UNITED STATES PATENT AND TRADEMARK OFFICE

APPLICATION NO.	FILING DATE	FIRST NAMED INVENTOR	ATTORNEY DOCKET NO.	CONFIRMATION NO.
10/505,302	05/09/2005	Alain Flers	003D.0030.UI(US)	6013

Office Action Summary	Application No.	Applicant(s)	
	10/505,302	FLERS ET AL.	
	Examiner	Art Unit	
	Omar Rojas	2874

DETAILED ACTION

FIG. 4

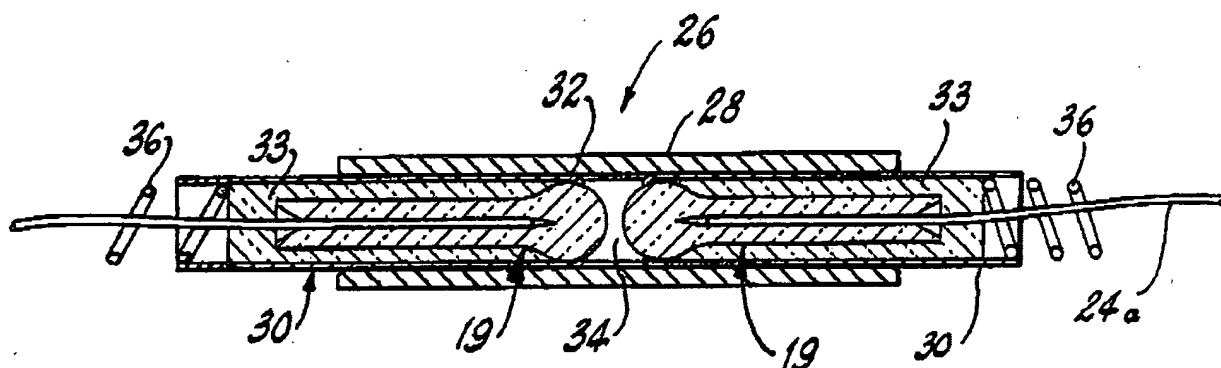
In re claims 1 and 2, Lynch discloses a module 26 comprising a package wherein said package has at least one optical waveguide section 18/19/24a interposed between an input optical port of the module and an output optical port of the module, wherein said optical waveguide section comprises at least one flared cone 19 enlarged at one end of the waveguide section and forming an optical input section, and further comprising an end lens 18. Figure 4 of Lynch is reproduced below.

In re claim 4, the lens 18 is made of a same material as that of the optical section 19.

In re claim 6, the compression springs 36 are inherently made of some type of metal. The term "metallized" is a method of forming step and, therefore, is not given patentable weight for similar

In re claim 8, as seen in Figure 3, part of optical section 24a is bent to lead into a plane.

In re claim 9, sleeves 28 and 30 of Lynch may be considered "standardized" receptacles.

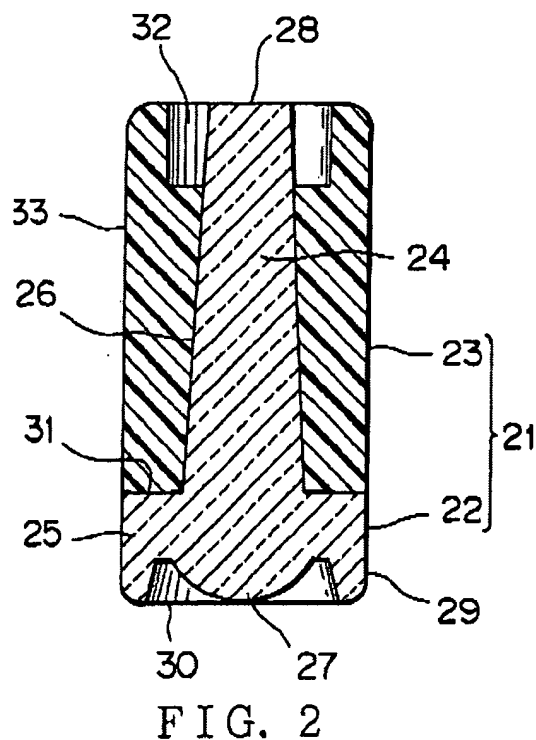
In re claims 1 and 2, Serizawa discloses a module (Figures 1-4) comprising a package wherein said package has at least one optical waveguide section 24 interposed between an input optical port of the module and an output optical port of the module, wherein said optical waveguide section 24 comprises at least one flared cone 26 enlarged at one end of the waveguide section and forming an optical input section, and further comprising an end lens 27. Figure 2 of Serizawa is reproduced below.

In re claim 3, the package comprises a material 23 that has a refractive index lower than that of the optical section 24.

In re claim 4, the lens 27 is made of a same material as that of the optical section 24.

In re claim 7, Serizawa further discloses a pedestal 44 having gripping grooves 44a and 50a.

In re claim 9, Serizawa discloses a "standardized" receptacle 42.
